Job Name: Land at Wandleys Lane (Application WA/73/17/OUT)
Job No: 38848-5501
Date: 10th January 2018
Prepared by: Gary Heard
Subject: **A27 Linsig modelling**

1. The following note has been prepared to address Highways England (HE) officer comments in relation to the planning application WA/73/17/OUT as set out in their emails of 18/12/2017 and 21/12/2017.

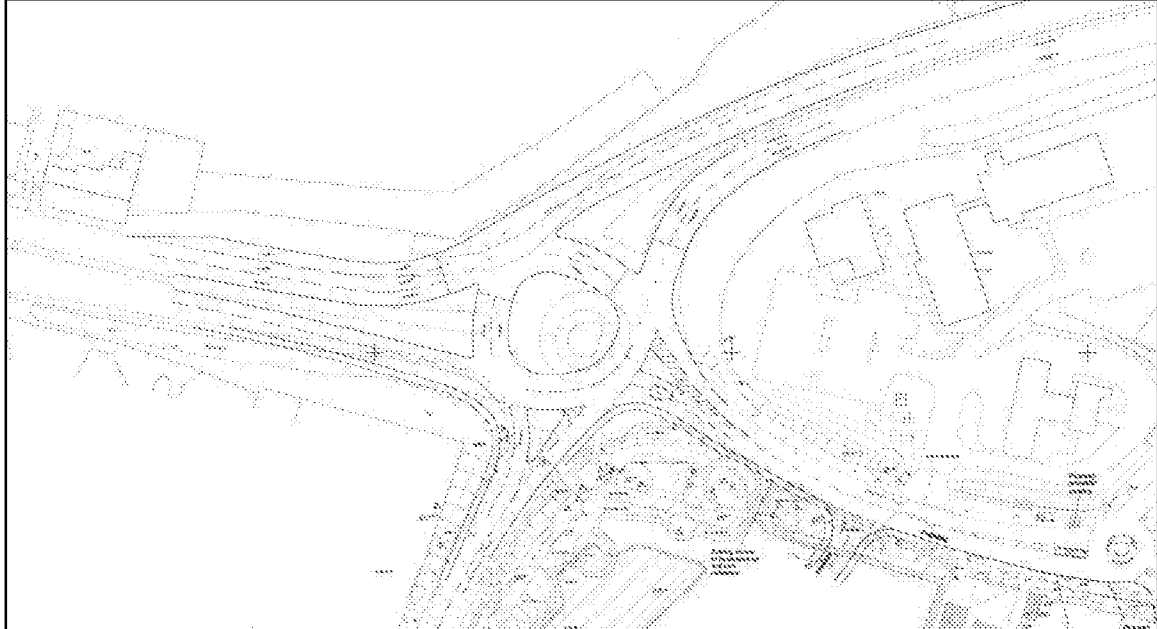
12. The Local Plan mitigation scheme for the west roundabout is illustrated below. It comprises partial signal control and kerb widening / realignment.

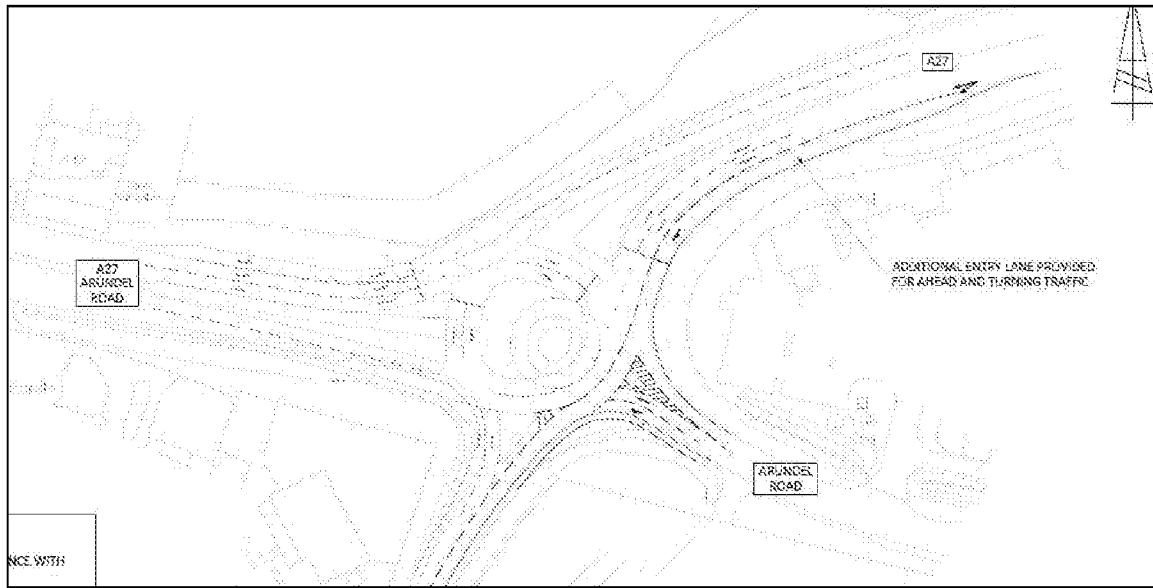
21. HE officers have requested a sensitivity assessment be completed that considers the Local Plan traffic flows plus the Tye Lane development flows and mitigation scheme for the west roundabout.
22. The mitigation scheme proposed for the Tye Lane development is illustrated below. It comprises a third lane added on the east arm of the proposed Local Plan mitigation scheme and an additional lane on the circulatory to allow for this.

26. It is noted that the AM and PM models demonstrate negative PRC values with -2.8% and -18.3% respectively. This compares to -0.9% and -6.4% (respectively) without Wandleys Lane.
27. Hence it is demonstrated that the Wandleys Lane development has a negative effect at this junction on the basis of the modelling described above.
28. A mitigation scheme has been considered that increases the flare length of the inside lane on the A27 east arm by 3 PCU lengths in the model.
29. The above model has been re-run after increasing the A27 east arm flare length. The model output (optimised for lowest PRC) is attached and summarised below.

30. It is demonstrated that the proposed mitigation results in at least a nil detriment solution with respect to PRC and on this basis offsets the effect of the Wandleys Lane development.

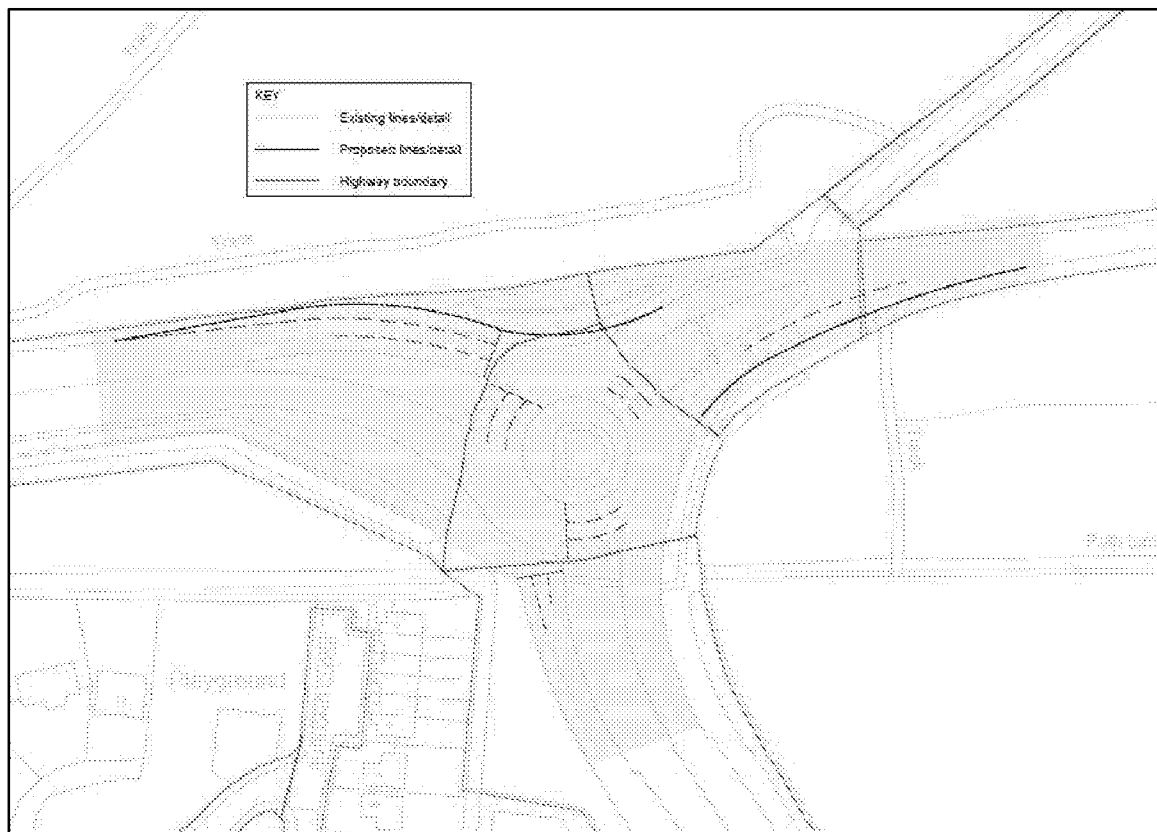
35. The Local Plan mitigation scheme for the east roundabout is illustrated below. It comprises partial signal control and kerb widening / realignment.
